A Review of the Shoreham Nuclear Power Station Probabilistic Risk Assessment

Internal Events and Core Damage Frequency

Brookhaven National Laboratory

Prepared for
U.S. Nuclear Regulatory
Commission

Table SE.2 Event Tree Diagram for Sequences Following Reactor Water Level Instrument Line Leak
(Sheet 2 of 9)

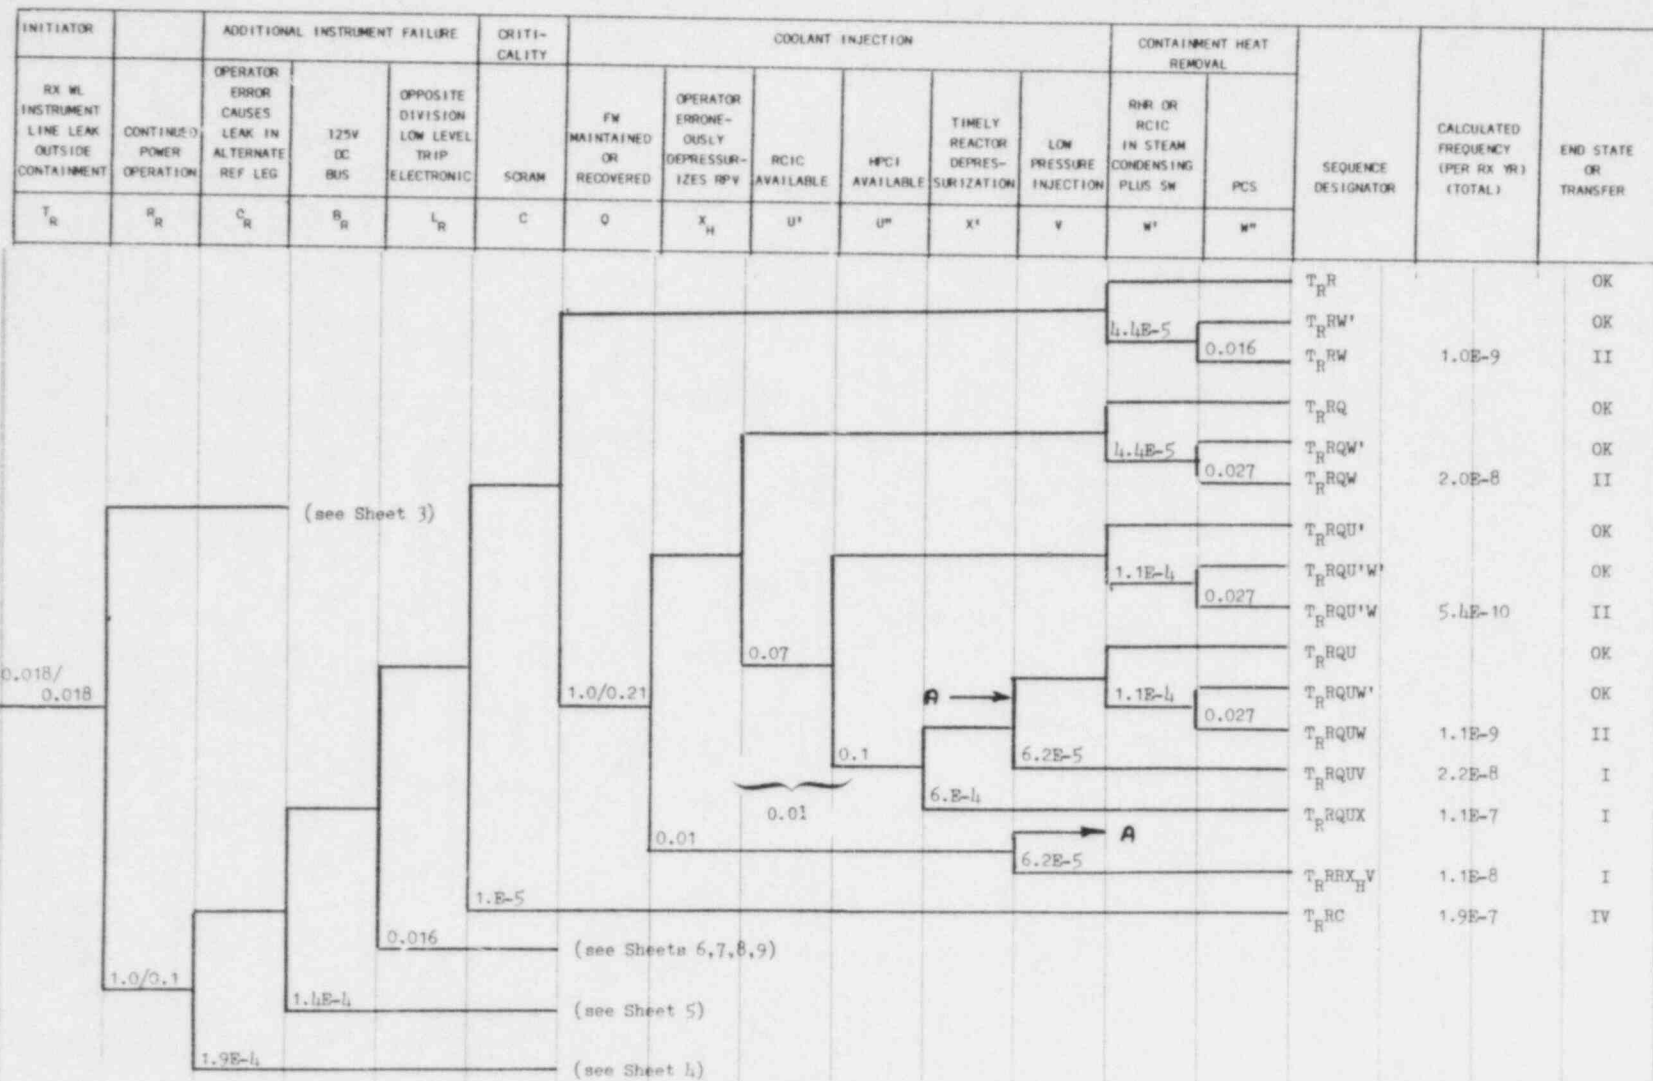
$Q = 0.21:$	If control is on leg B ($\approx 10\%$ of the time) and leg B failure occurred, then a feedwater runback may result. The value for recovery of feedwater is taken from the loss of FW event tree in Appendix 5A. The value used by SNPS apparently was not updated for the change of MSIV trip logic to level 1. (See Appendix 5A Table 5A.7 for an update of BNL value to 0.12.)
$X_H = 0.01:$	This function was added by BNL to the event tree and means "Operator Erroneously Initiates ADS". This is taken from the functional fault trees of the SNPS study (Figures D.5 and D.6), and was explicitly included in the BNL assessment on the event tree. This value is the same as in the SNPS study.
$U' = 0.07:$	Fault tree calculated RCIC unavailability.
$U'' = 0.1:$	Fault tree calculated HPCI unavailability.
$U = 0.01:$	Fault tree calculated RCIC and HPCI unavailability.
$X = 6.E-4:$	Fault tree calculated ADS unavailability is 8.4×10^{-4} , which includes miscalibration error of level 1. This contribution to ADS unavailability was deducted, since it is treated explicitly in sheet 6.

Table 5E.2 Event Tree Diagram for Sequences Following Reactor Water Level Instrument Line Leak
 (Sheet 6 of 9)

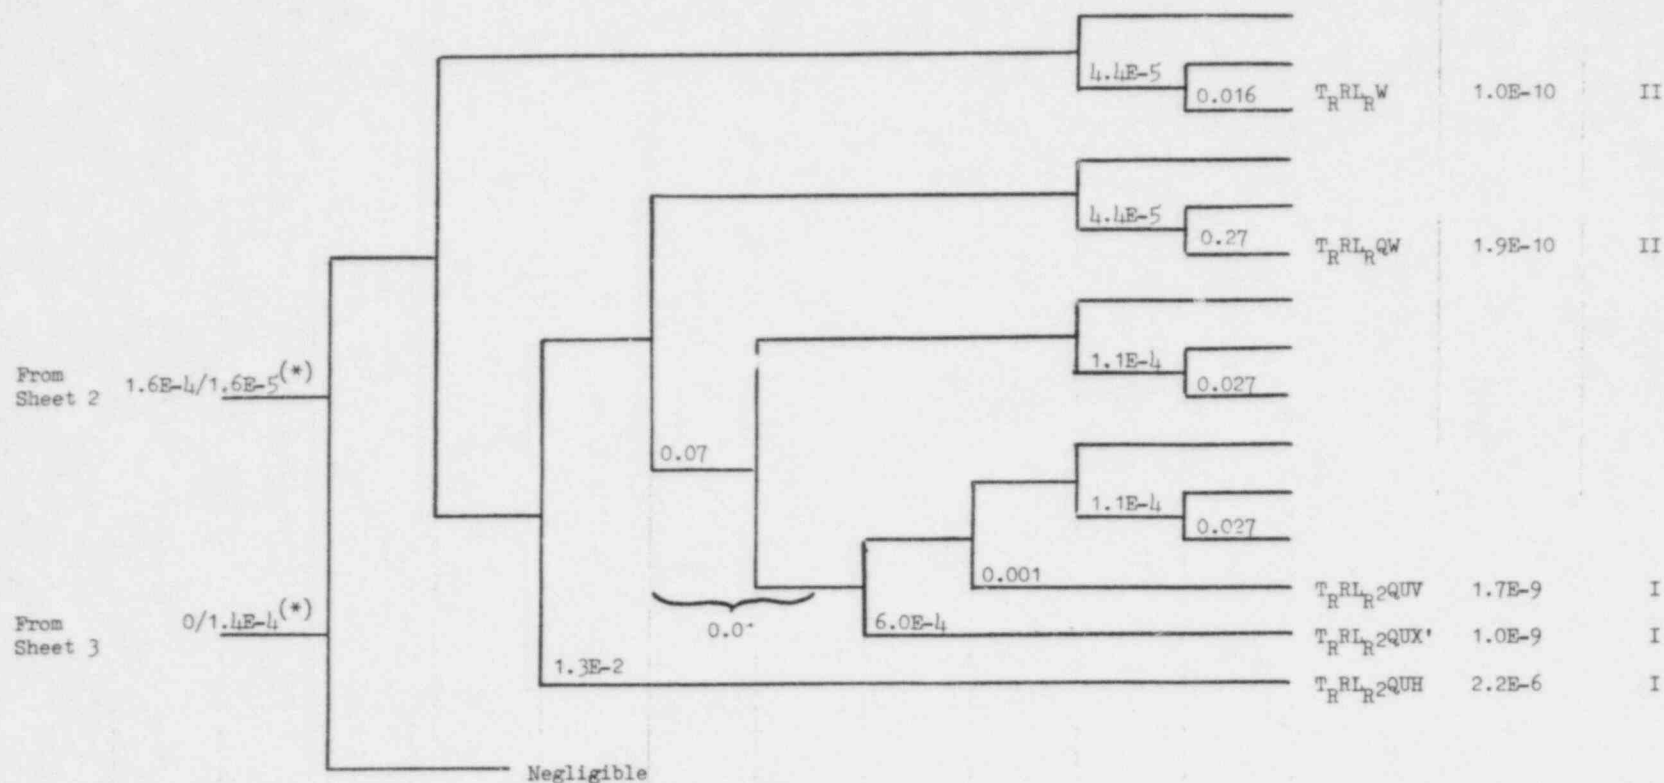
- $L_R = 3.6E-5 /$
 $3.6E-6$
 $0.0 / 3.2E-5$: The upper line is for the case of feedwater trip (Transfer from Sheet 2)
The lower line is for the case of continued operation. (Transfer from Sheet 3). It is assumed that a miscalibration of the instrumentation on the other leg existed while the reference leg leakage occurred. This was assumed in the SNPS study, but treated as affecting one additional channel rather than two.
- $H = 0.062$: As in the case of the loss of a DC bus, the miscalibration prevents any automatic initiation of HPCI, RCIC, ADS, LPCI, or LPCS. If the operator fails to recognize the need to initiate core cooling injection, the core would eventually uncover, and no automatic prevention is available.
